DEVIATION REQUEST AND DECISION FORM

Project Name :	Rocky Top Resources
Schedule No.(s) :	6429101029, 6429101030, 6429101031
Legal Description :	TRACT 7 VALLEY GARDENS AS AMD BY ADMINISTRATIVE VAC OF INTERIOR LOT LNS BY REC #206006560 TRACT 1 VALLEY GARDENS, EX THAT PT CONV TO COUNTY BY BK 3823-439 & TO HWY BY BK 5973-205, TOG WITH THAT PT BY VAC RES 04-545, REC #206179579 TRACT 2 VALLEY GARDENS, EX THAT PT CONV TO COUNTY BY BK 3823-439, TOG WITH THAT PT BY VAC RES 04-545, REC #206179579

A deviation from the standards of or in Section 2.3.7.E of the Engineering Criteria Manual (ECM) is requested.

Proposed Turn Lane Design*

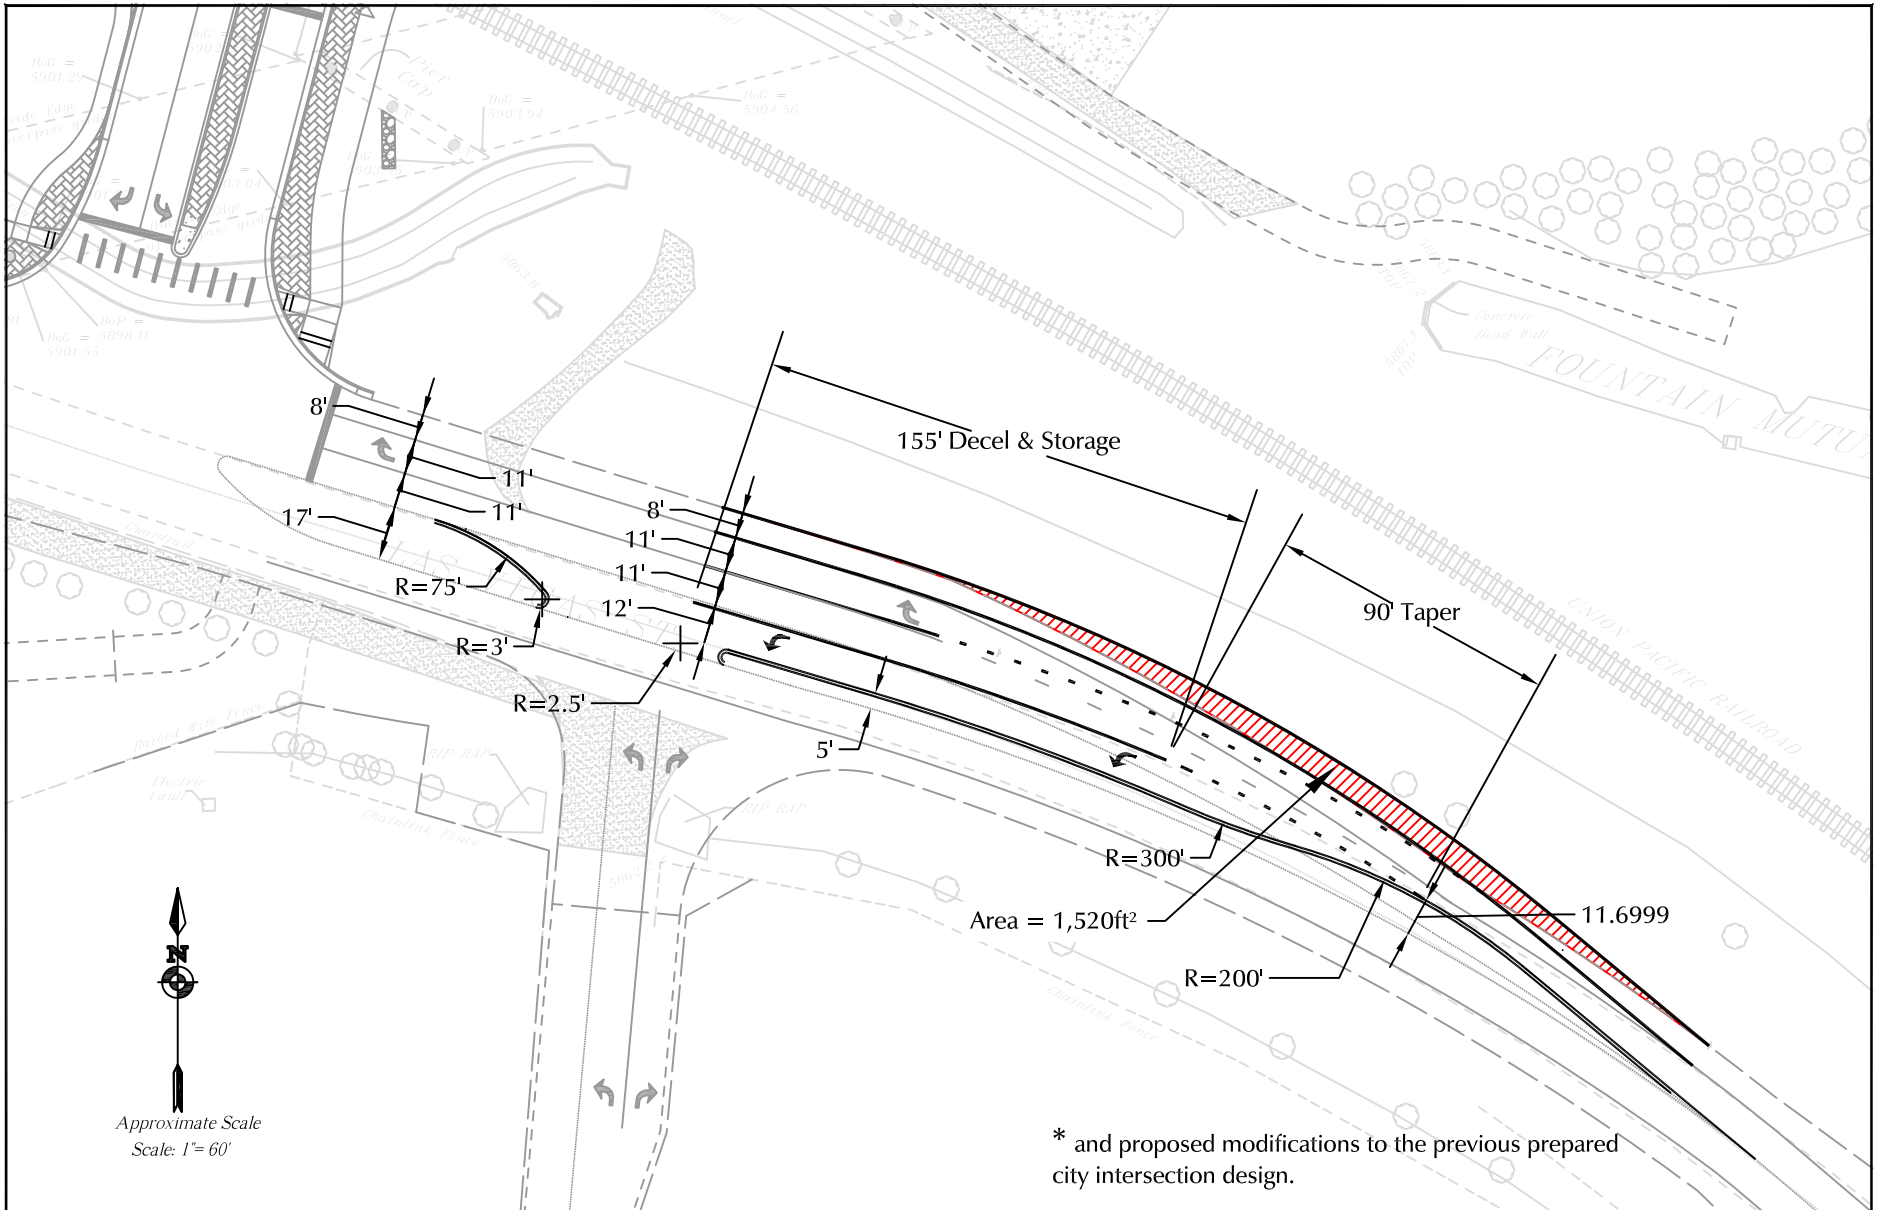
Standard 2.3.7.E (Intersections –Turn Lane Design) requires that the westbound left-turn lane into the site have 50 feet of storage, 195 feet for deceleration, and 180-foot taper. There is an existing two-lane bridge located approximately 500 feet east of the access. Accommodating the full auxiliary lane, taper, (and the required lane redirect taper, which would not be modified) would not be feasible given the distance between the access and the bridge.

The standards require westbound left-turn lane have 50 feet of storage, 195 feet for deceleration, and 180 -foot taper (or 90-foot bay taper). The proposed alternative is 50 feet of storage (meets the standard), 105 feet for deceleration (90 feet short of the standard), and a 90-foot bay taper. Per the ECM "A minimum taper ratio of 8:1 may be used for tangent bay tapers in constrained locations. Bay tapers should be used (asymmetrical reverse curves) for deceleration transition tapers." The 90-foot bay taper would be six feet short of the 8:1 ratio (96'). See attached exhibit.

The bridge to the west of the site limits how far back a lane redirect can begin, which limits the turn lane. The proposed design deviation is not expected to negatively impact safety on the corridor due to the low number of turning vehicles at this intersection. It should be noted that the site is very seasonal and only exceeds the turn lane threshold on Saturdays during peak months (between April and September). Additionally, because the volume of turning vehicles only exceeds the turn lane threshold on Saturdays, the through volume on Las Vegas Street is lower and the 95th percentile queue for the turning movement is less than one vehicle.

The deviation still allows for the standard storage length, 105 feet of the required 195 feet of deceleration distance and a bay taper within 6 feet of a taper length with an 8:1 ratio (which "may be used for tangent bay tapers in constrained locations") storage for the westbound left.

Providing any turn lane for this movement is an improvement over the current roadway layout, which has vehicles making the westbound left-turn from the through lane. The bay taper plus deceleration length is equal to the required deceleration length, so operations and safety should not be adversely impacted. The 150-foot left-turn lane plus bay taper is a typical length in urban areas.

The proposed deceleration lane, although short of the ECM requirements, would maximize the distance possible between the access point and the bridge to the east. The lane would allow for left-turning vehicles to get out of the through lane to complete deceleration (to a potential stop condition) to make the left turn. Following vehicles may need to reduce speed slightly more than if the lane were able to be constructed to the standard length to allow for the initial deceleration of the turning vehicle approaching the access, but this is not uncommon in urban areas and/or areas with constraints to turn-lane length..

This request has been determined to have met the criteria for approval. A deviation from Section 2.3.7.E of the ECM is hereby granted based on the justification provided.
